## Access Compliance Report Public Rights-of-Way (Curb Ramps)

Intersection ID: 16835Main Street: HARTNESS\_AVCross Street: WALKER\_RDLocation:NWADA ID: B3058365F582Ramp Type: PerpDiagInitial Pass/Fail: FailOverall Compliance: NoSeverity Score:10

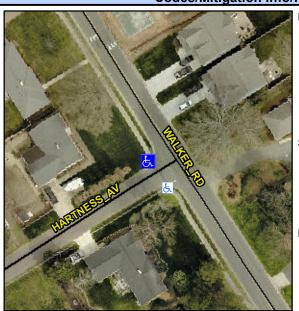
Not Found, R304.5.1, R304.5.3

Compliance Description Date		Data		liance Description	Data
N/A	Ramp Length (in)	28.0	Yes	Ramp Slope (%)	8.1
No	Ramp Width (in)	43.5	No	Ramp XSlope (%)	2.5
N/A	Flare Type LT	N/A	N/A	Flare Type RT	N/A
N/A	Flare Slope LT (%)	N/A	N/A	Flare Slope RT (%)	N/A
N/A	Flare Traversable LT?	N/A	N/A	Flare Traversable RT?	N/A
N/A	Landing Length (in)	N/A	N/A	DWS Provided?	N/A
N/A	Landing Width (in)	N/A	N/A	DWS Contrast?	N/A
N/A	Landing Slope (%)	N/A	N/A	DWS Length (in)	N/A
N/A	Landing X Slope (%)	N/A	N/A	DWS Full Width?	N/A
N/A	Landing Curb? (Y/N)	N/A	N/A	DWS Offset (in)	N/A
N/A	Shared Landing?	N/A			
N/A	Gutter Ponding?	N/A	N/A	Gutter Slope (%)	N/A
N/A	Gutter Lip Ht (in)	N/A	N/A	Gutter X Slope (%)	N/A
N/A	Painted X Walk1?	No	N/A	Painted X Walk2?	No
	X Walk 1 Direction	To SE		X Walk 2 Direction	To E
N/A	X Walk 1 Width (in)	N/A	N/A	X Walk 2 Width (in)	N/A
	X Walk 1 Slope (%)	3.1		X Walk 2 Slope (%)	0.3
	X Walk 1 X Slope (%)	0.5		X Walk 2 X Slope (%)	3.1

Remove & Replace Curb Ramp With Two New Directional Ramps or Equivalent.
